Planning and Regulatory Committee

Date: **Wednesday 30 July 2025**

7. 251273 - CAR PARK (PLOT 1A & 1B) TOGETHER WITH PLOTS 4 & 5, EAST OF WIDEMARSH STREET, HEREFORD, HEREFORDSHIRE, HR4 9JU Proposed flood alleviation scheme to address historic flooding across the Merton Meadows area of the city.	79 - 204

HYDROCK PROJECT NO. 35849		SCALE @ A1 1:1000	STATUS S2
STATUS DESCRIPTION SUITABLE FOR INFORMATION			
DRAWING NO. (PROJECT CODE-ORIGINATOR-ZONE-LEVEL-TYPE-ROLE-NUMBER) 35849-HYD-1-XX-M3-C-90110		REVISION P05

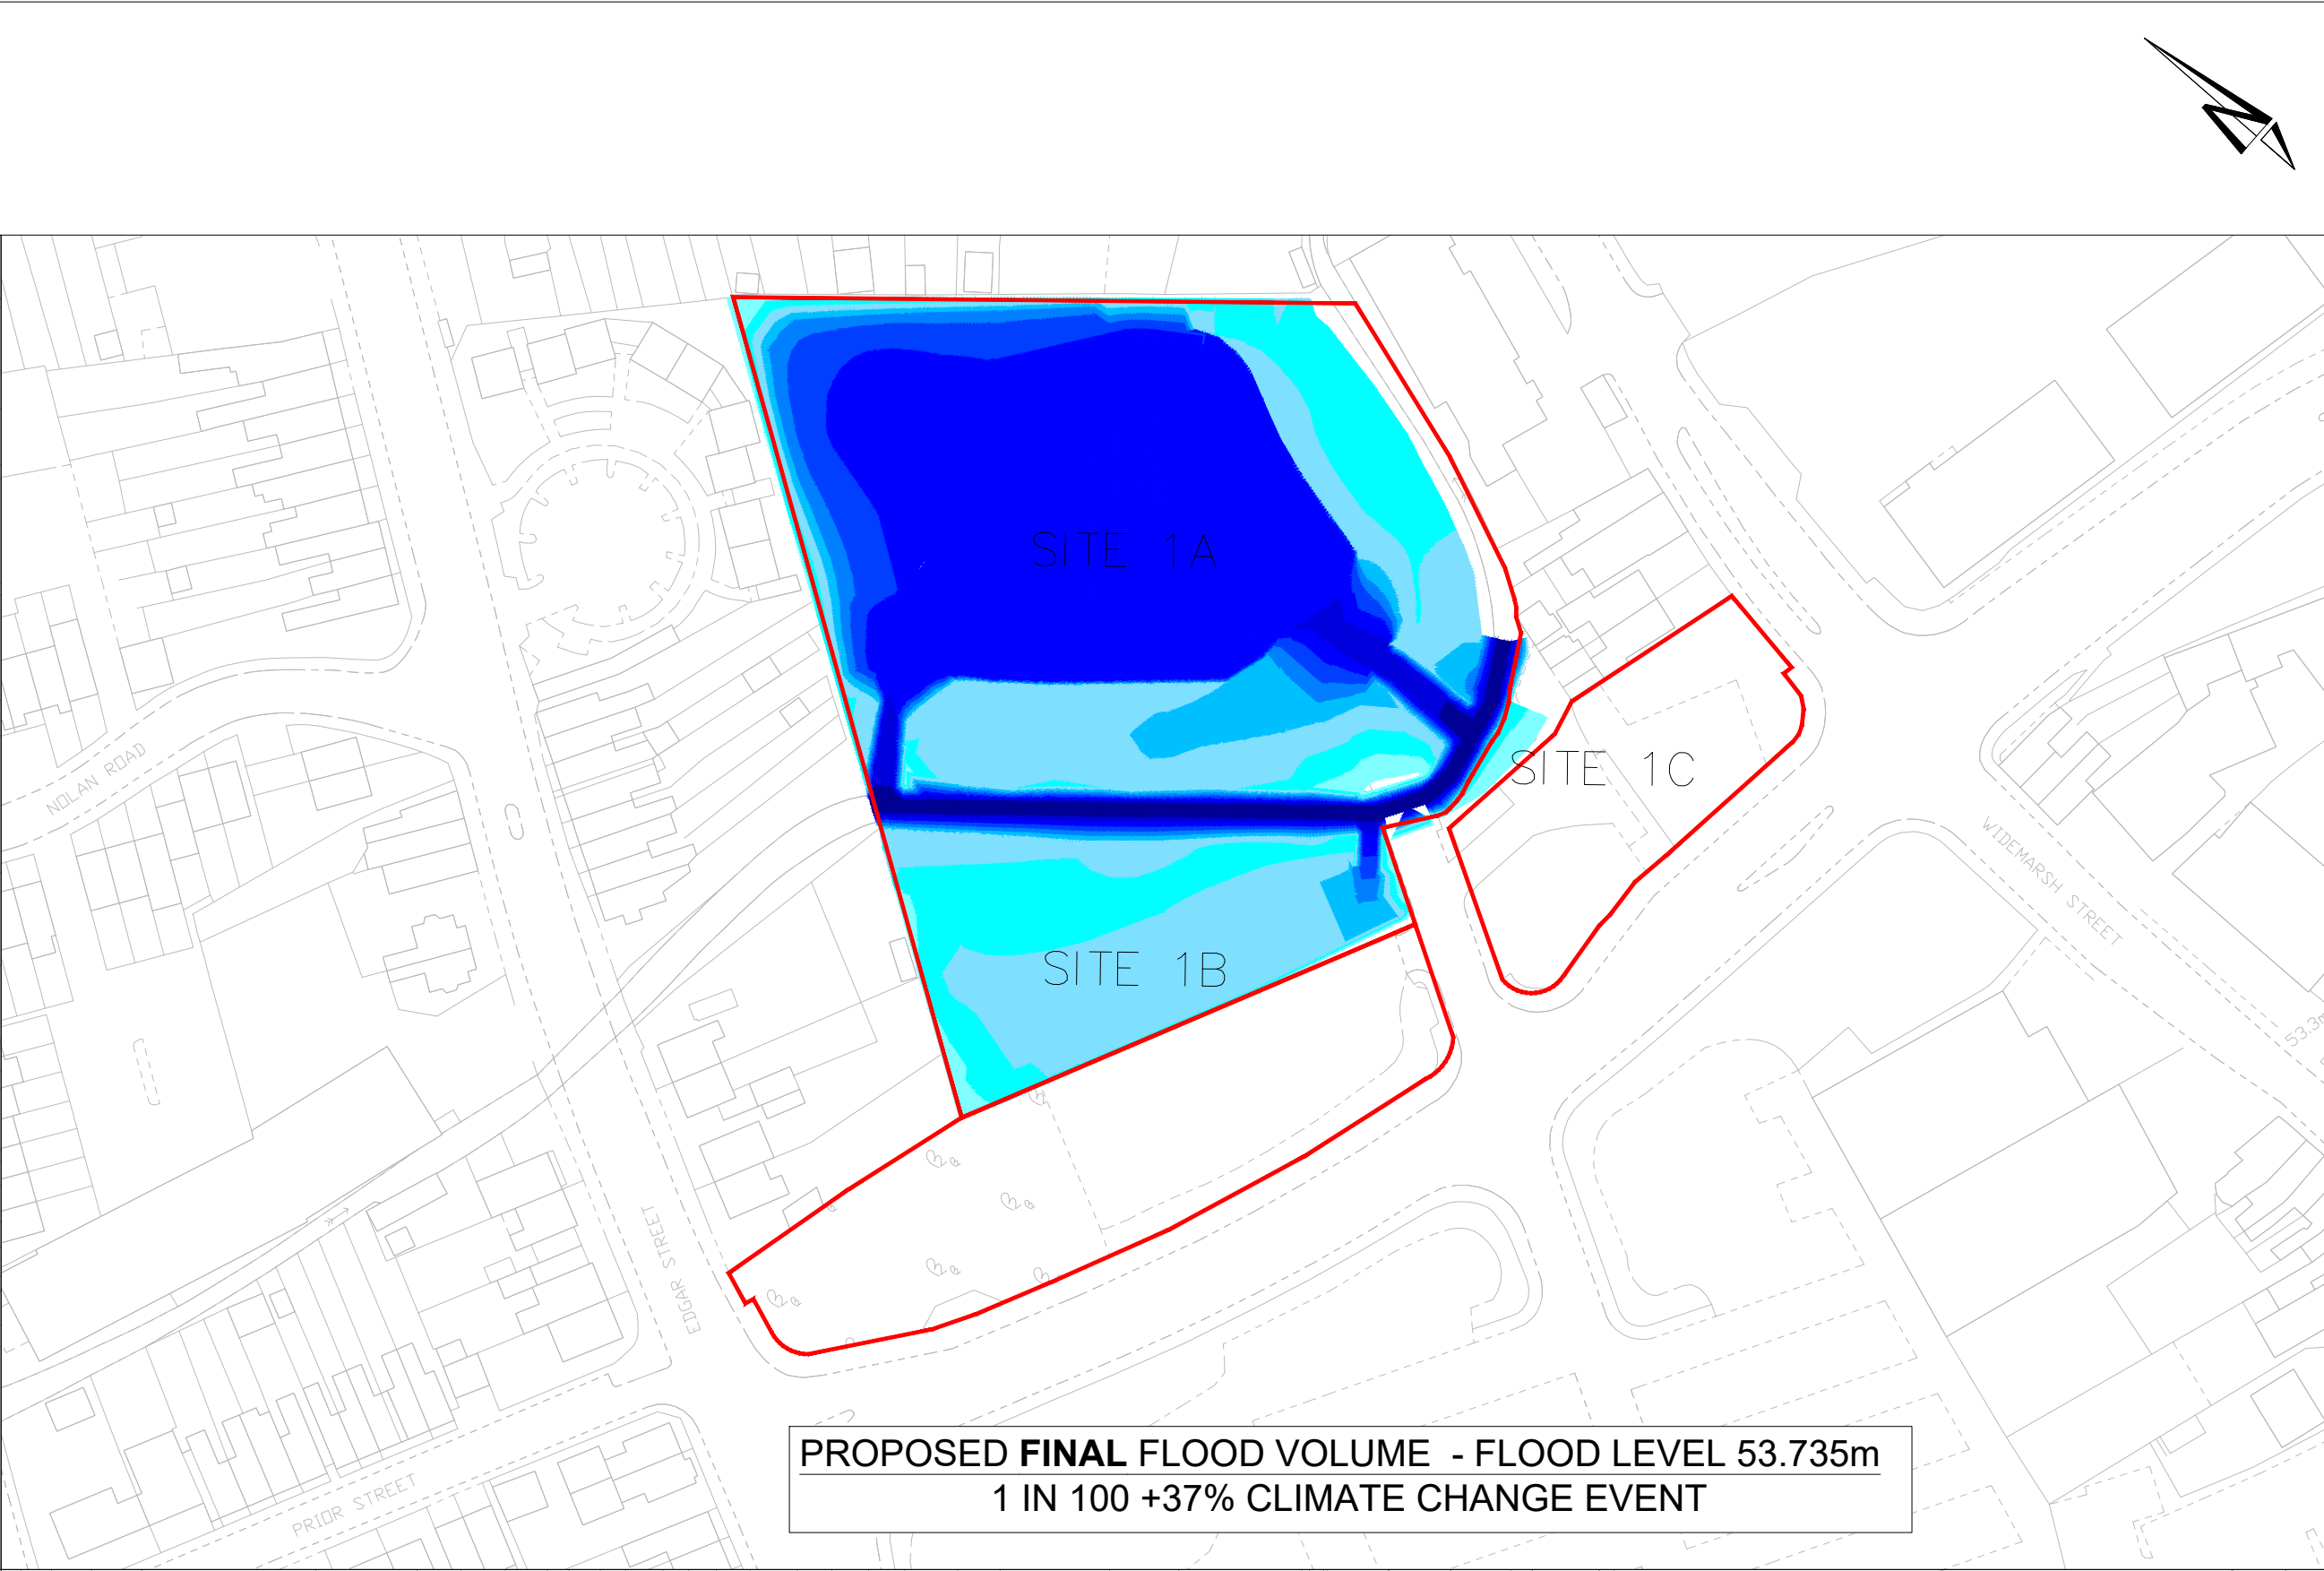
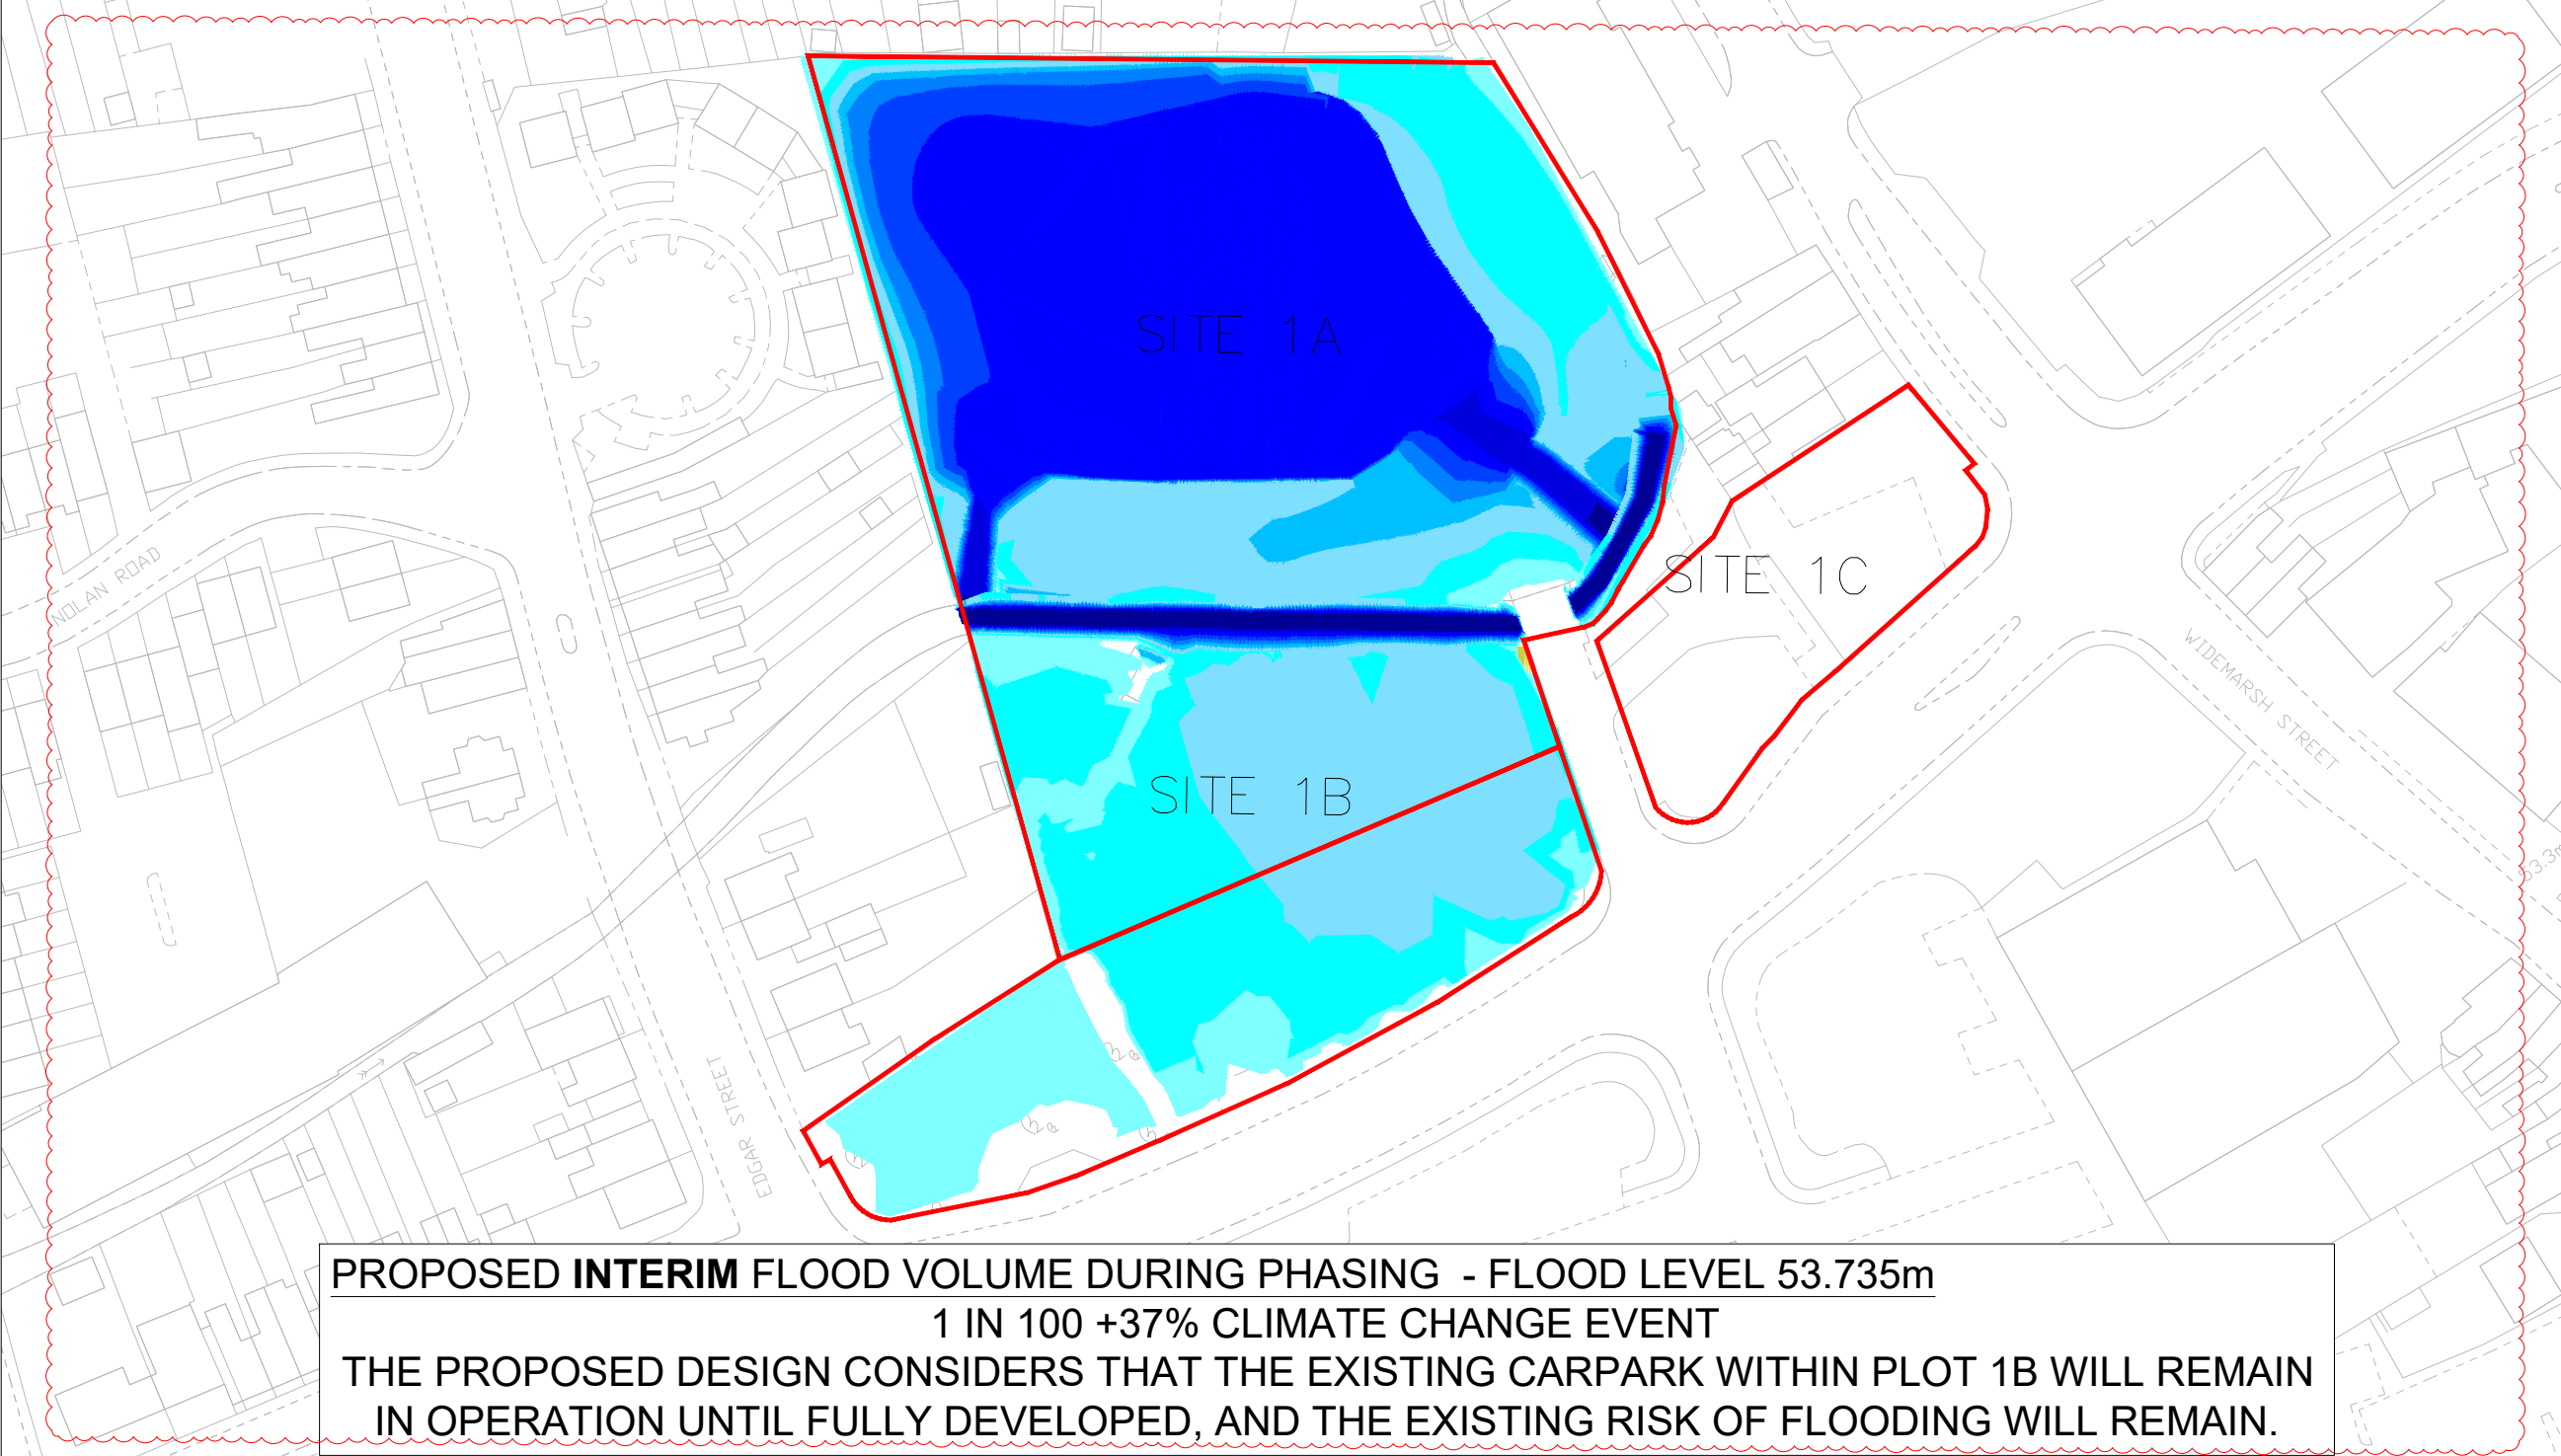
The Flood Compensation Volumes drawing 1A 1B 1C identifies a 100 year + CC level of 53.73m AOD. The boardwalks are raised to 53.90m AOD with the intent of providing a safe access.

THE PROPOSED FINISH GROUND LEVELS MIGHT CHANGE PENDING OF THE WATER LEVEL IN THE BROOK AND AGREEMENT WITH ENVIRONMENT AGENCY.
